Access Compliance Report

Public Rights-of-Way

(Pedestrian Signals)

Intersection ID: N/A	Main Street:	Cross Street: N/A	Location: N/A
ADA ID: 416FD0D93FD7	Signal Type: Two Push Buttons-Non APS	Overall Compliance: No	Severity Score: BTN 1:N/A BTN 2: N/A No BTN: N/A
Codes/Mitigation Info/Possible Solution		Field Measurements/Component Compliance

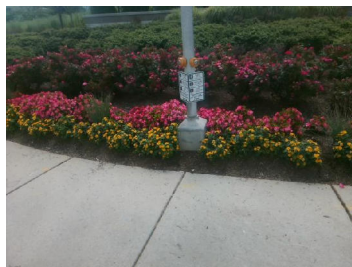
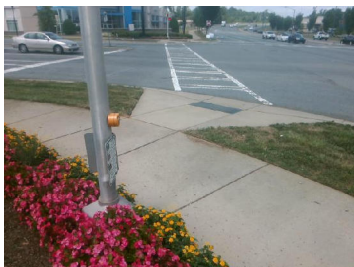
Surveyor Notes: TEXT HT 7/16

PROW/ADA: R410.6, R209.1, TMUTCD 4e.08, R404.2, R406.2, R404.7.3

Possible Solutions: Replace Signal Push Button With APS Button on New Post. Remove & Replace Sign.
